# Review of Soil and Land Components of Hills of Gold Wind Farm Environmental Impact Statement and its Soil and Water Amendments

29<sup>th</sup> March 2022

Prepared by Greg Chapman Certified Practicing Soil Scientist (Soil Science Australia), Director Land and Soil Capability.

This document and its attachments are copyright of Land and Soil Capability and are only to be used within the context of the purpose of the document. This document is a review of soil and land components of amendments of the proposed Hills of Gold Wind Farm Environmental Impact Statement

*Figure 6 Hardstand for WTG 12 compared to local terrain. Image source Brian Tomlin of HOGPI*

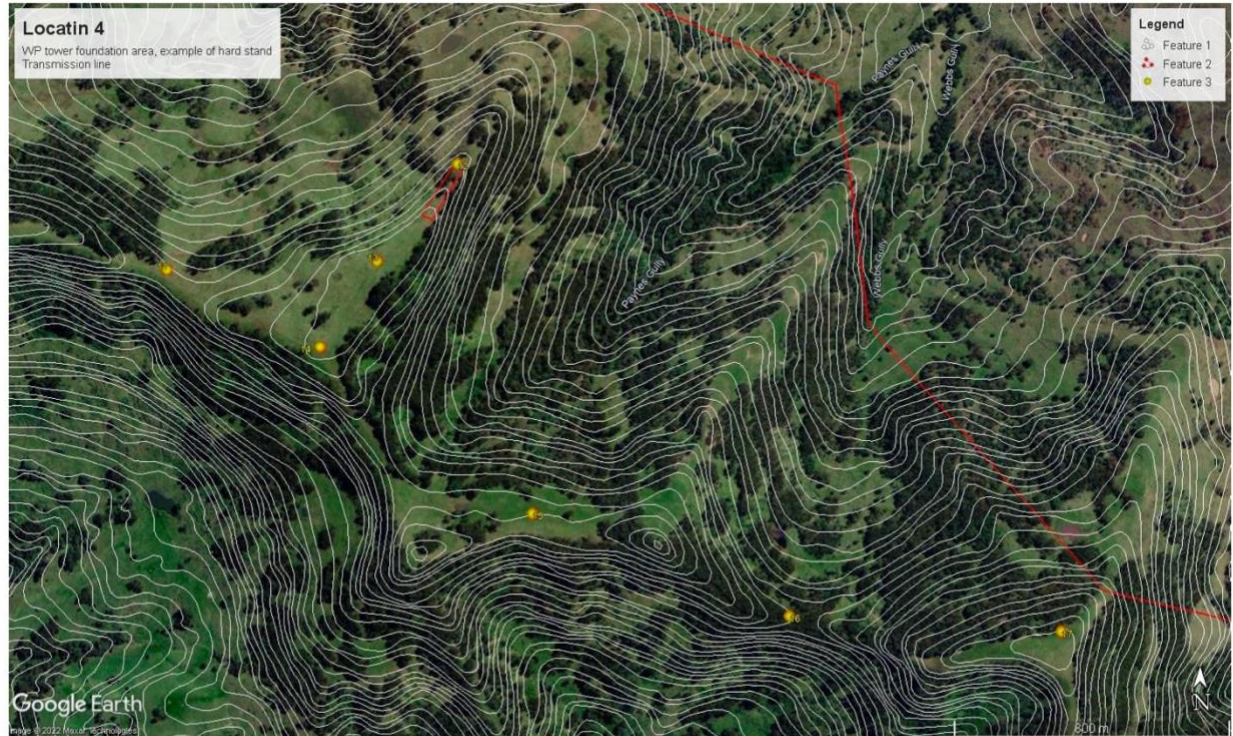
In another example, provided by Brian Tomlin of HOGPI, it can be seen that turbine number 12 is proposed for installation on a knife-edge spur. See figure 5. Brian has superimposed the location of the necessarily level ie horizontal hard stand (for fitting parts and crane operations), which is understood to be 150m by 60 metres on a 10m interval contour map. Three ten metre contours can be seen crossing the proposed hardstand foot print, indicating that a 30m batter will be required. Mass movement hazard given the steep slopes and geology is extreme. Simple geometry, assuming: 1) that crane and component weights will require a cut surface; and 2) a stable vertical batter is even possible; indicates that some 135,000 metres of earth and rock ( $15/2 \times 150 \times 60$  cubic metres) could need to be removed from this single component of the proposed development. Whilst other WTGs for the development may not be in as extreme locations, the point is that the environmental impact, due to the extent of earthworks and its associated soil conservation challenges has not been assessed.

**Map 4:** WP tower locations showing 25-30m foundation area with WP12 hardstand on top of 1169m ridge requiring a 20-30m cut

Figure 7: One of the slope maps for the proposed development

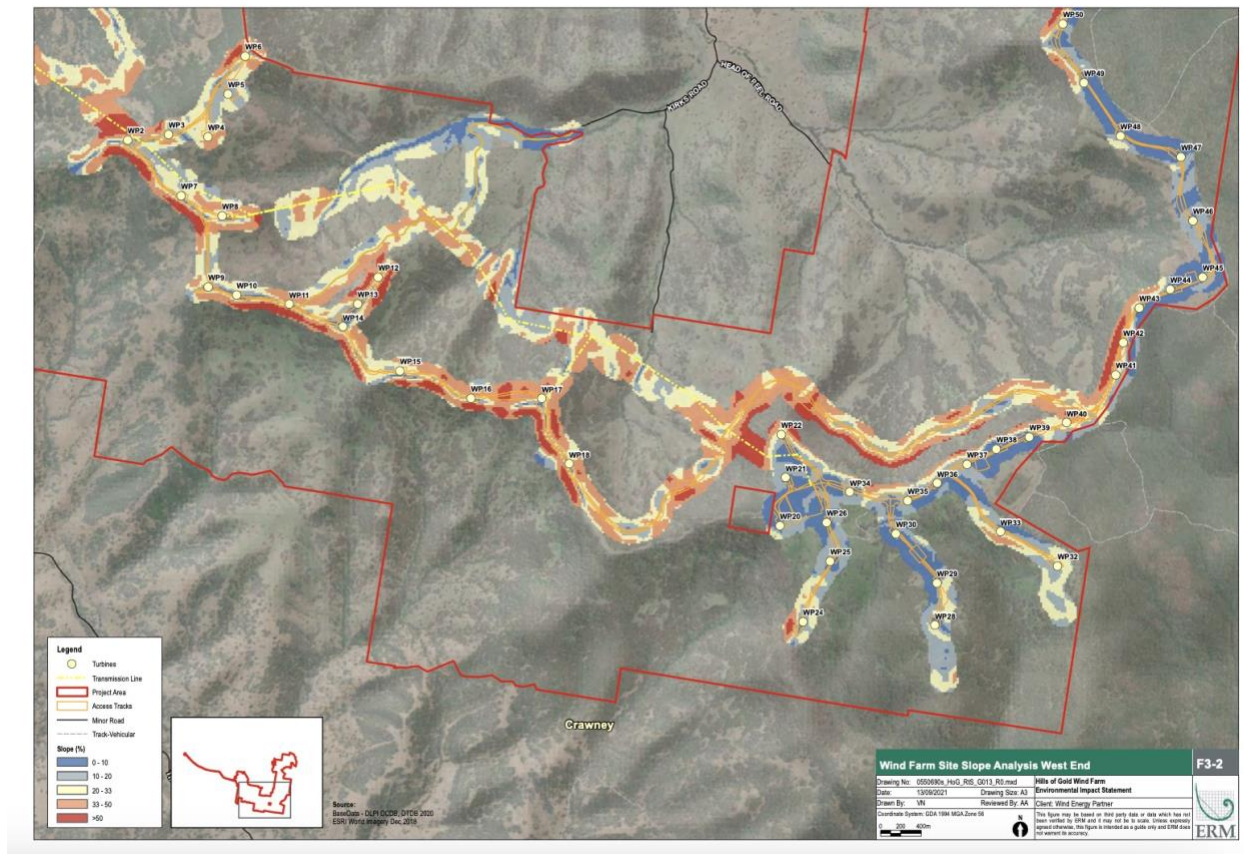
Slope maps in the amendment of the EIS show numerous steep instances along proposed roads (It is understood that there are about 40km of road within the site where turbine blades of around 80 metres, and other oversize heavy loads are to be delivered). In figure 7 it can be seen that there are numerous places where roads are planned for slopes which exceed 20% ie 1 in 5 (in brown) and to a lesser extent between 33% and 50% (1 in 3 to 1 in 2 slope) (in red). (Slope classes beyond the construction buffer are inexplicably not shown). NB The NSW Soil Conservation Service generally identifies slopes greater than 18 degrees (33%) as being Protected Land- requiring a permit to remove trees.

To place this in context, many local governments do not allow driveways where the slope exceeds 15%. Mine haul roads generally have upper gradient limits of 10%

On the slope map, it can be seen (Figure 7) that several kilometres of the proposed road traverses a steep northern facing slope, ie below the ridge top. Much of this land has slopes between 33 and 50% (1 in 3, and 1 in 2 gradients- Protected Land). This section, and other smaller sections where the road runs along a hill slope, rather than along a ridge top, will require cut and fill batters. This is problematic on unstable steep hill sides, as greater amounts of cut and fill are required on side slopes when: 1) the transverse slope is steeper, and/or 2) the road needs to be wide eg 7 to 18m (see turning circles above) depending on the nature of the curve and 3) the vehicle is heavy – requiring a greater degree of insitu

Figure 9 Turning radius diagram for transported blades

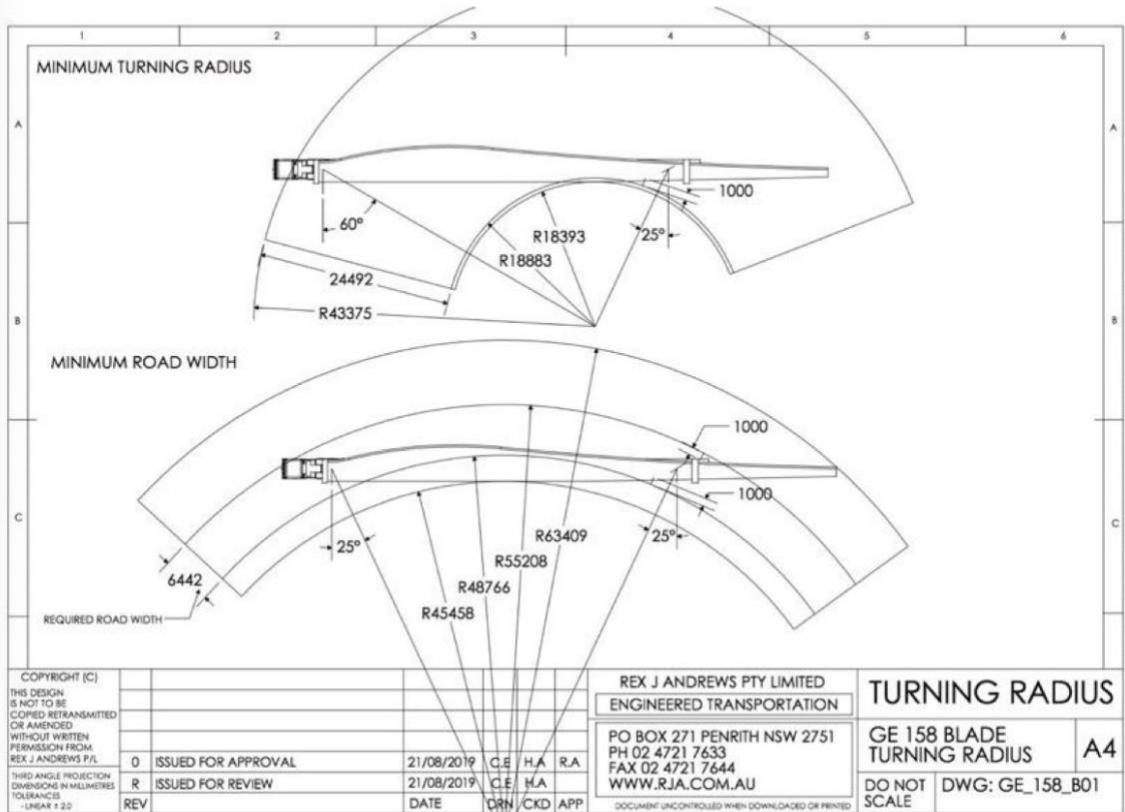
No specific information concerning required turning radii for delivery of turbine blades is provided in the EIS, nor in appendix G which deals with roading issues. The closest is the diagram, provided by Rex J Andrews in Appendix G. See figure 9. It appears, from interpretation of the unexplained diagram, that the minimum road width is to be around 6.45m, with an inner turning radius of around 45.5m, and an outer radius, to accommodate the rotor tail, of some 63.5m.

Given: 1) the length of the truck and 2) overhang of the blades which are between 83 and 75 metres, an enormous turning circle of at least 45.4m and up to 63.4m radius is required. This means broad sweeping turns with cuttings on **inside** ie concave, curves around 18m wide (*equivalent to a six lane highway*) if the back of the blade is below ground level. Road width on **outside** ie convex curves, according to the diagram would seem to need to be 7m or more wide (a bit wider than a standard two lane road). This is because the tail of the blade can hang out into space on some outer bends. To allow sufficient turning space to accommodate steep rises the route must be circuitous. This is salient as restricted turning involves further soil disturbance. Furthermore, inside bends are typically valley crossings. An extreme erosion hazard is expected where large volumes of disturbed construction material for a six lane wide road is placed in a drainage line! Perhaps other methods such as bridging

may be used. Regardless major works such as this which have the potential and risk of movement of thousands of tonnes of soil material is not dealt with in the EIS.

Figure 11 Wind turbine blade on proposed semi-trailer shown in appendix G of the EIS. What are the clearance angles?

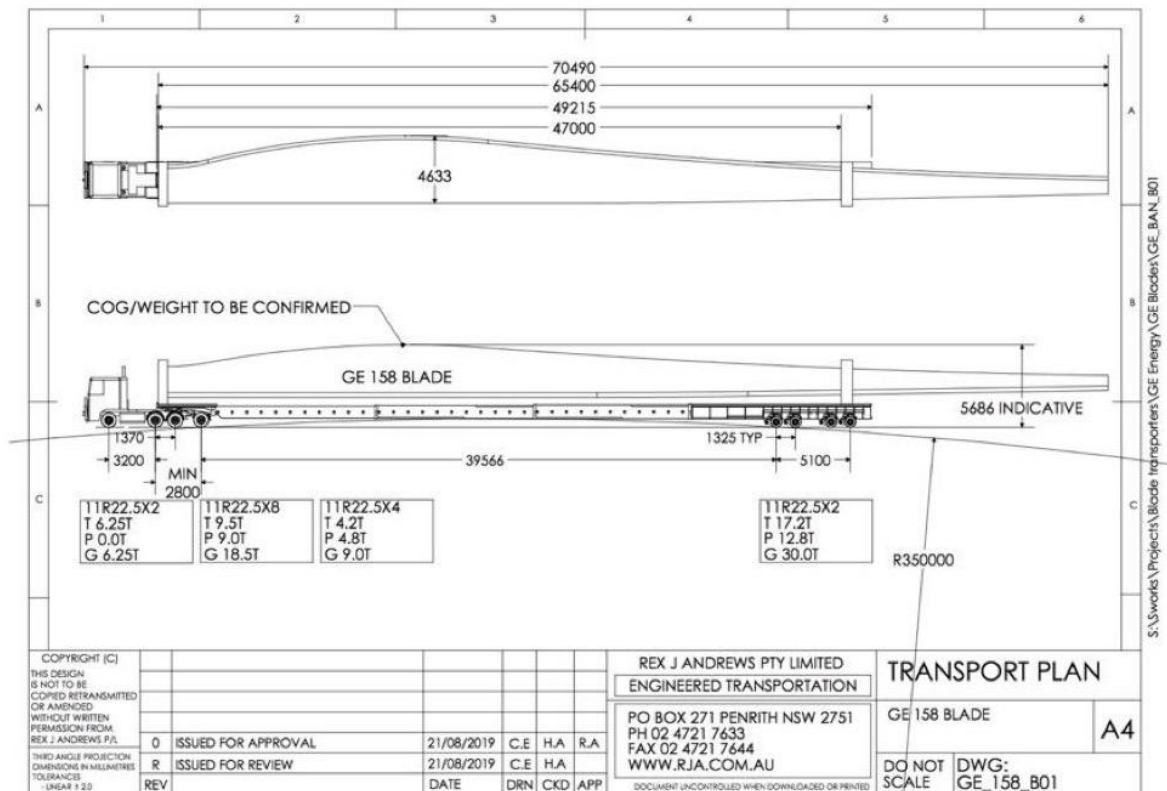
Breakover and departure angles will have little tolerance if a 70m plus blade is being carried. See figure 11. Other truck configurations carrying even heavier loads for nacelles and other parts may be even more restricted by their wheel configurations.

Clearance angles have not been specified in the EIS for any of the proposed delivery vehicles – and the example of the blade vehicle may not be the most critical. Clearance criteria is another factor which governs road geometry. It is consequentially another factor which increases the amount of cut and fill and impacts drainage – hence erosion, sedimentation, drainage, mass movement risk and water quality. The EIS has made no attempt to address these considerations.
